**Champlain Hudson Power Express ("CHPE")
Environmental Management & Construction Plan
Notice of Major Change**

Project: Champlain Hudson Power Express

Notice Number: 140

Location (Milepost, Town/County): Schenectady Preferred MP 2.4 to 2.9, Town of Glenville, Schenectady County, NY

Deviation Zone Analysis

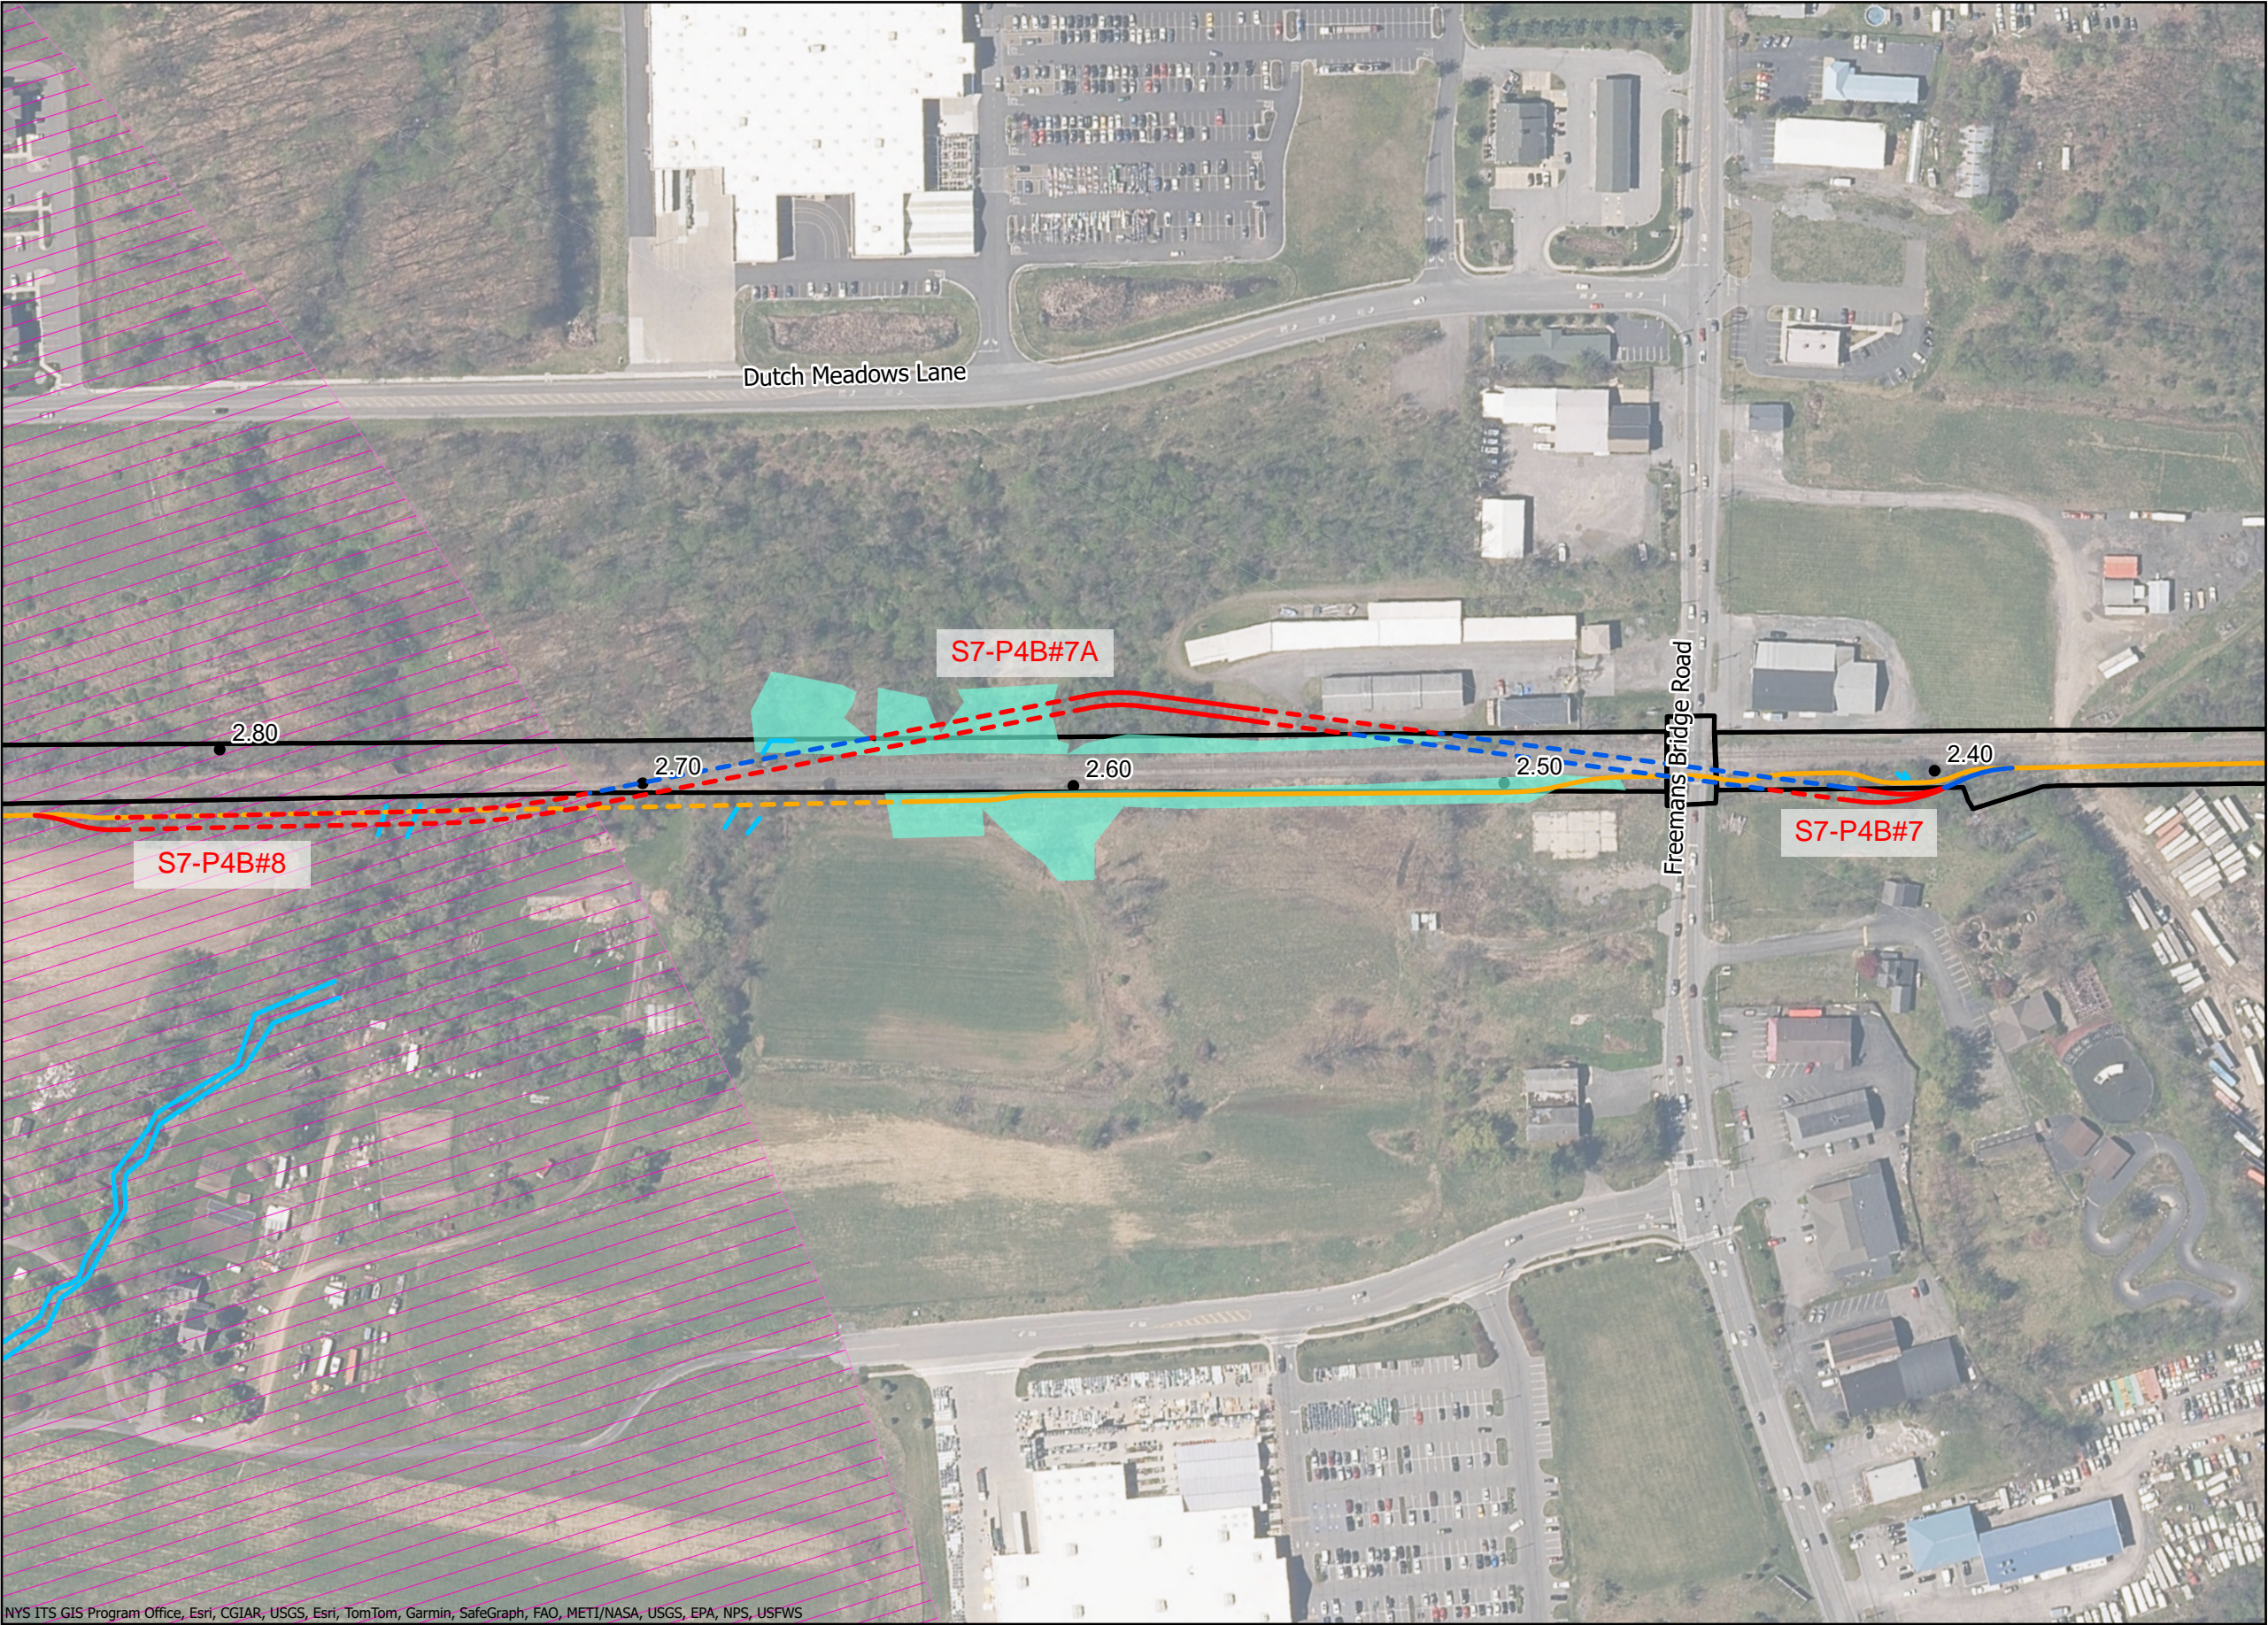
Implementing a trenchless crossing of Freemans Bridge Road while avoiding Lands N/F Ultimate LLC requires an alignment change crossing the CSX tracks and a new excursion on the north side of the tracks. A new access road and work area is required north of the tracks for the construction of HDD 64AA. This work area includes 0.06 acres of new temporary wetland impacts to Wetland JG. An update to EM&CP Table 9.2 included below shows updated wetland impact areas. Additionally, the alignment of the previously-approved HDD 64A from approximately station 45137 to 45146 has been altered to cross below the CSX tracks, tying this change into the previously-approved alignment. Overall, the altered portion of the alignment is from approximately station 45126 to station 45146.

The length of the excursion is approximately 704 linear feet, and approximately 352 linear feet are HDD below grade with no surface disturbance. The proposed excursion occurs approximately 54 linear feet north of the ADZ at the farthest point.

This excursion is required for workspace for HDD 64AA for the trenchless crossing of Freeman's Bride Road (NY State Route 911F) and to avoid impacts to Lands N/F Ultimate, LLC, currently undergoing soil contamination remediation. This ADZ Excursion request is grounded in engineering reasons and is the minimum necessary to feasibly achieve the installation.

DRAWING NO.
C-109

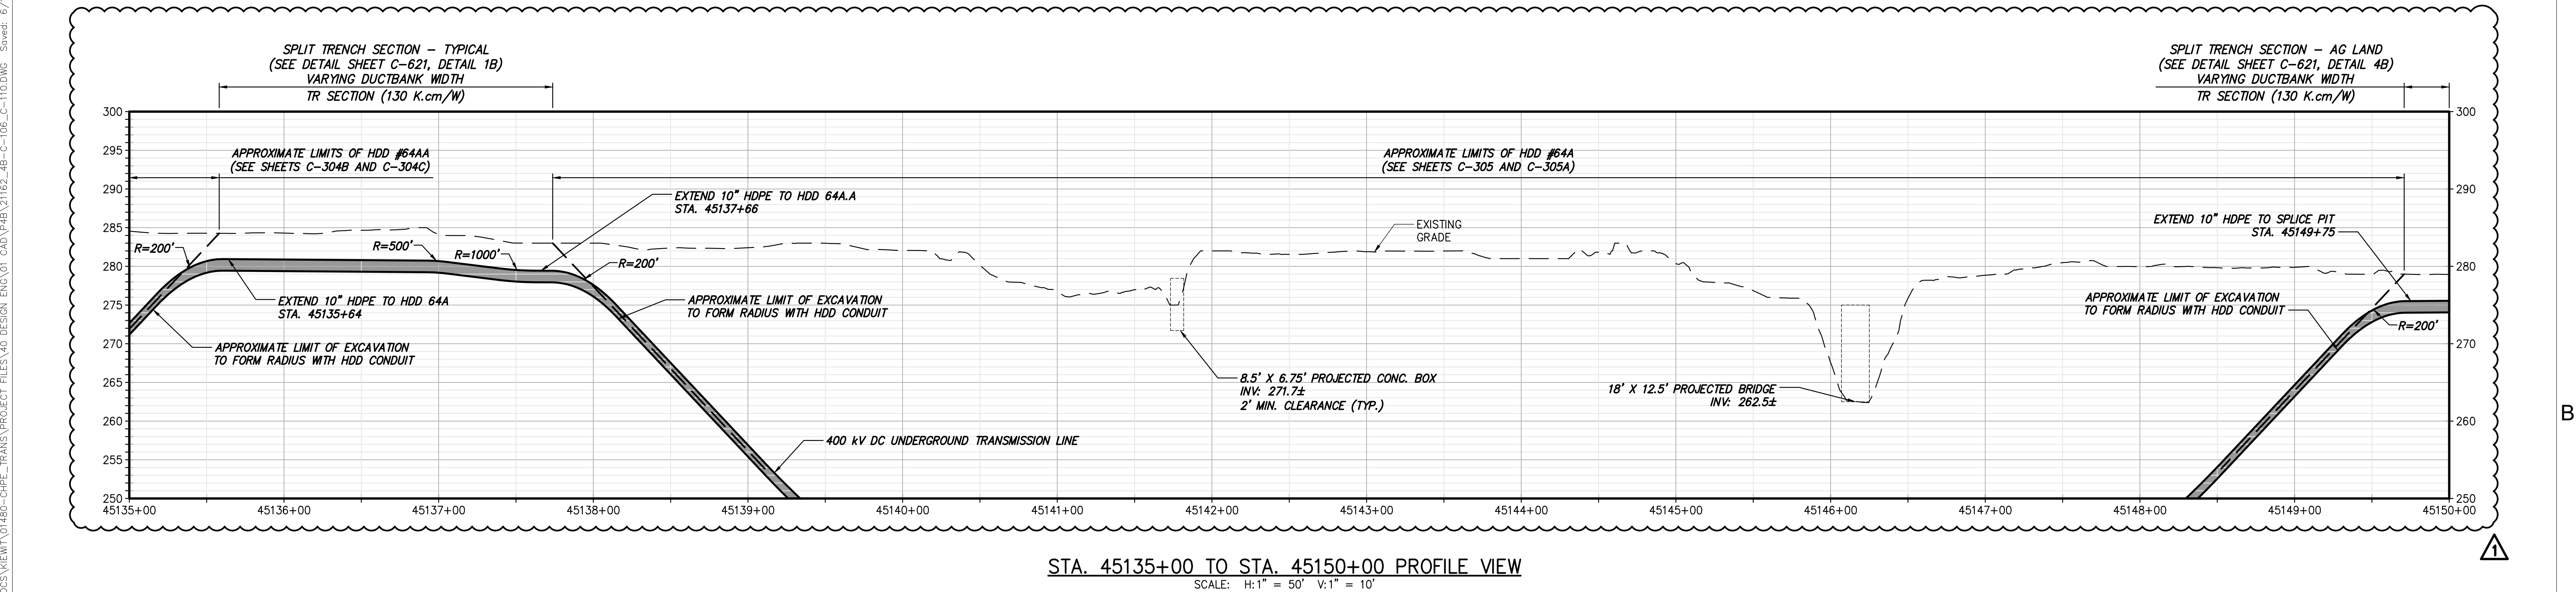
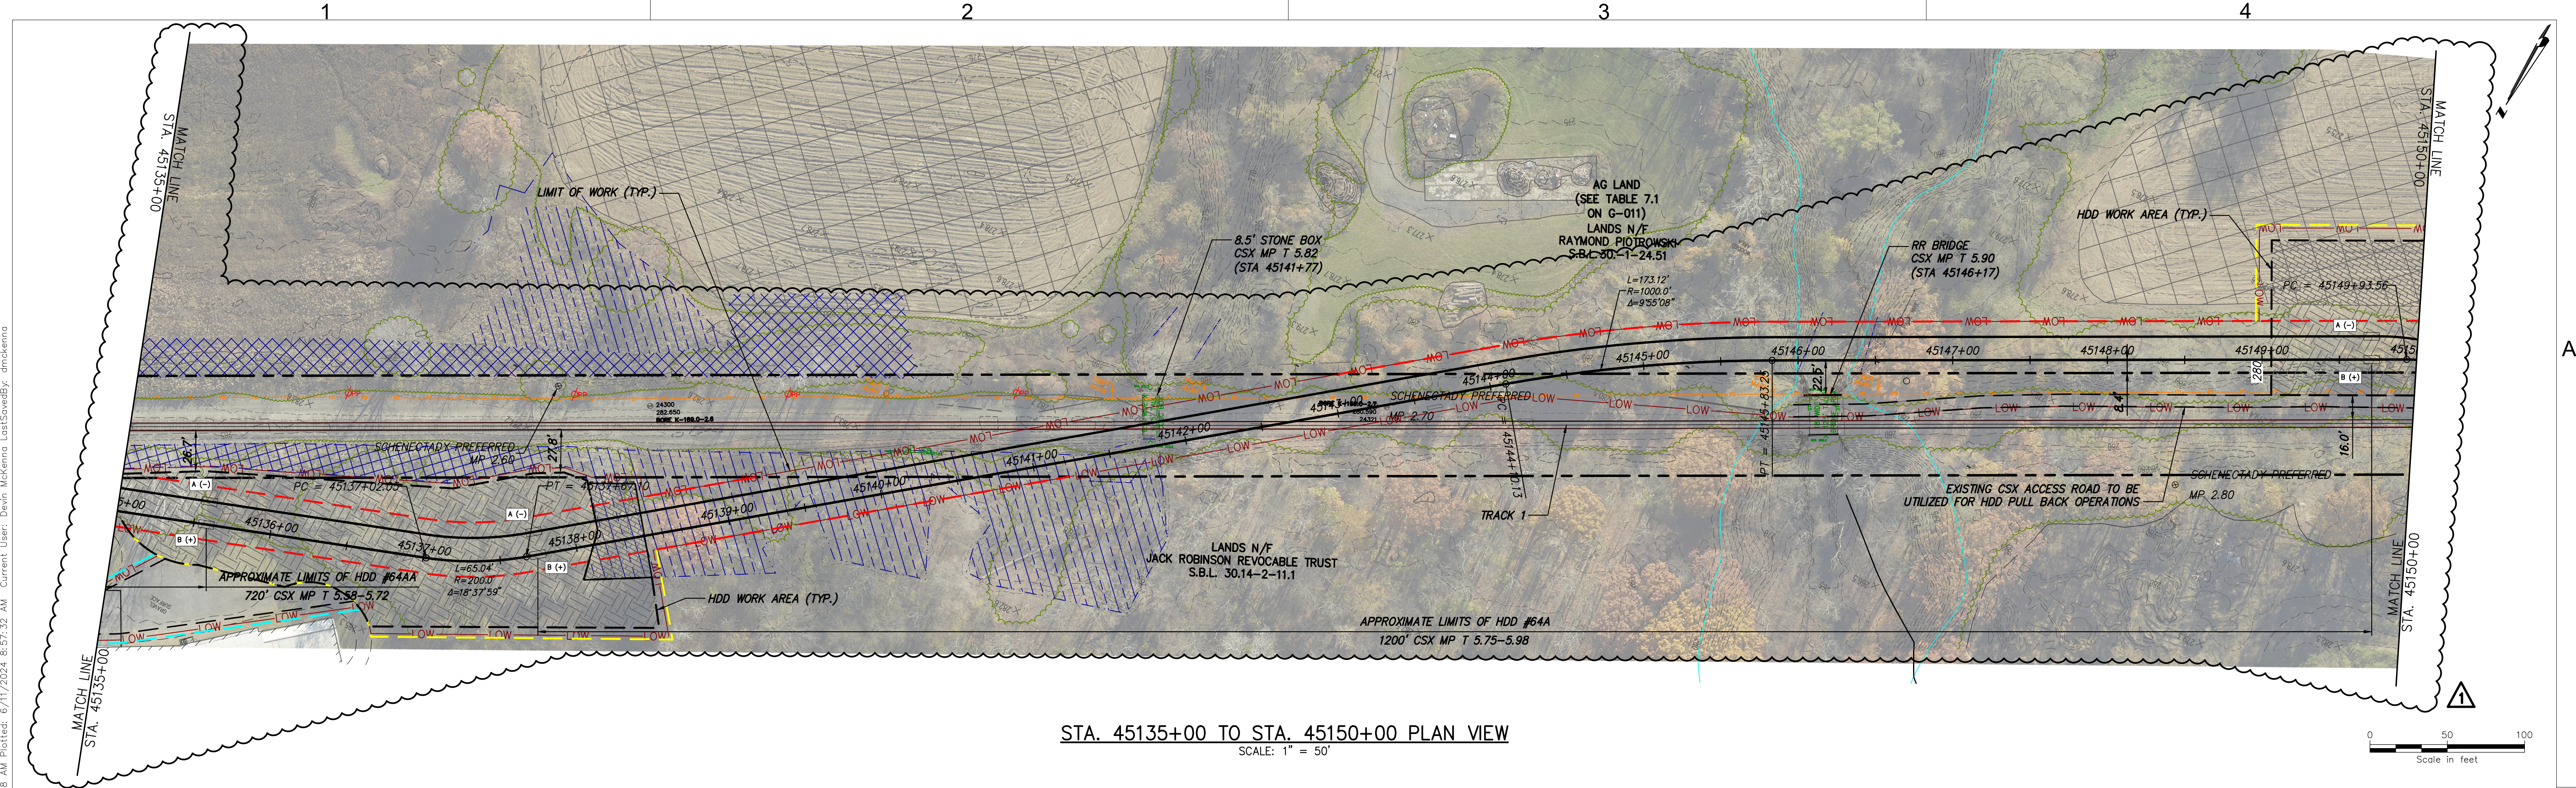
This change eliminates previously-approved trenched conduit installation, temporary access road, and HDD work area on the south side of the CSX tracks from approximately station 45130 to 45140, referencing station numbers of that design ("ISSUED FOR CONSTRUCTION SUBMISSION", dated 07/28/2023). Approximately 0.64 acres of wetland impacts (wetlands C-PA-E and FA-XQ) associated with that temporary road and work area have been eliminated. An update to EM&CP Table 9.2 is included below.

Sheet No.	Rev No.	Revision Description	Summary
G-001	3	NDC-0063: HDD 64AA, HDD 64A REDESIGN	Added C-305.1, C-305A.1, C305B, and C-305C
G-011	2	NDC-0063: HDD 64AA, HDD 64A REDESIGN	Updated Table 4.7
G-013	2	NDC-0063: HDD 64AA, HDD 64A REDESIGN	Updated Tables 4.1, 4.2, & 5.2
G-014	1	NDC-0063: HDD 64AA, HDD 64A REDESIGN	Updated Table 4.4B
G-015	1	NDC-0063: HDD 64AA, HDD 64A REDESIGN	Updated Tables 8.4, 12.3, & 13.3
C-109	2	NDC-0063: HDD 64AA, HDD 64A REDESIGN	Added HDD 64AA so that Freeman's Bridge Road is crossed by HDD instead of trench. Alignment changed to allow sufficient space for HDD pits and for HDD to avoid Lands N/F Ultimate, LLC (30.14-2-12). LOW added east of Freemans Bridge Road for HDD work area. Access road added west of Freeman's Bridge Road to work areas for HDD64AA and 64A.
C-110	1	NDC-0063: HDD 64AA, HDD 64A REDESIGN	Continuation of alignment change discussed above (C-110). Returns to previously-approved alignment at 45145+83. LOW added for HDD HDD 64AA/64A entry (combined) and HDD 64A exit.
